MIL-C-60174(MU)
AMENDMENT 2
23 April 1968
SUPERSEDING
AMENDMENT 1
21 April 1967

MILITARY SPECIFICATION

CONNECTOR, ELECTRICAL, RECEPTACLE: 10526125

This amendment forms a part of Military Specification MIL-C-60174(MU), dated 19 March 1965.

FIGURE 1 MECHANICAL GAGE

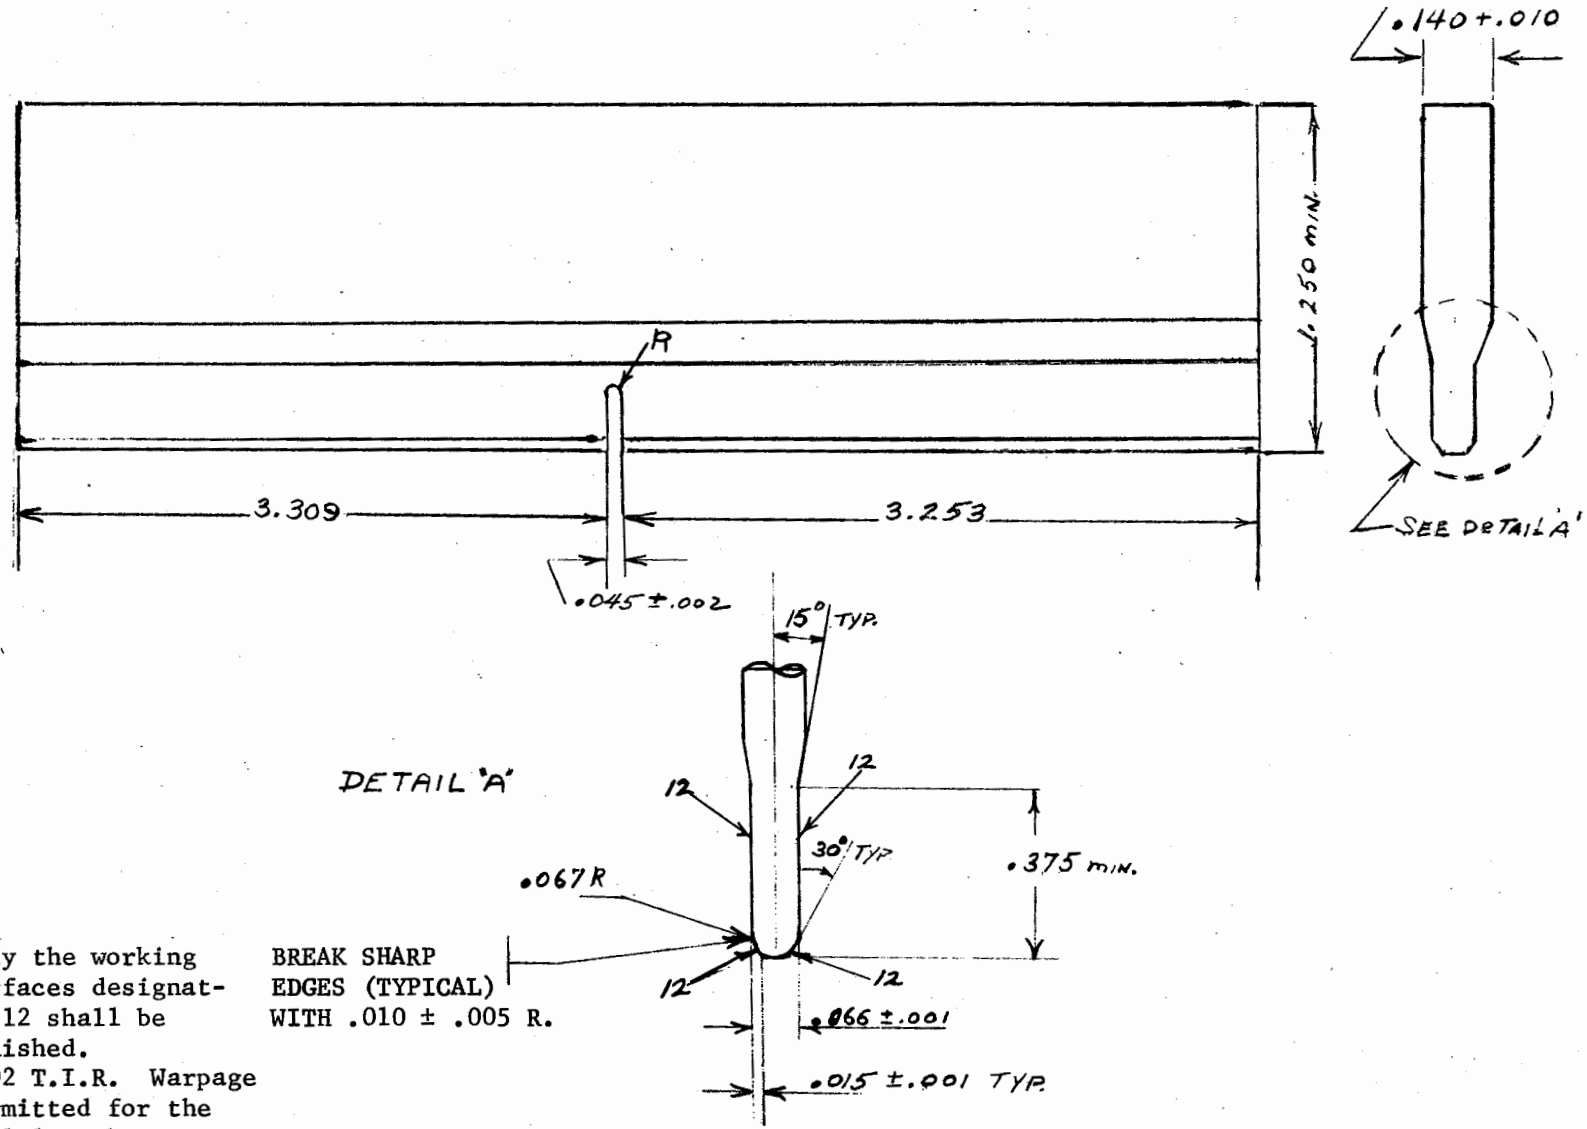
Add "Item 10 Steel gage.- Outline as shown in Figure 1".

Add: Figure 1.
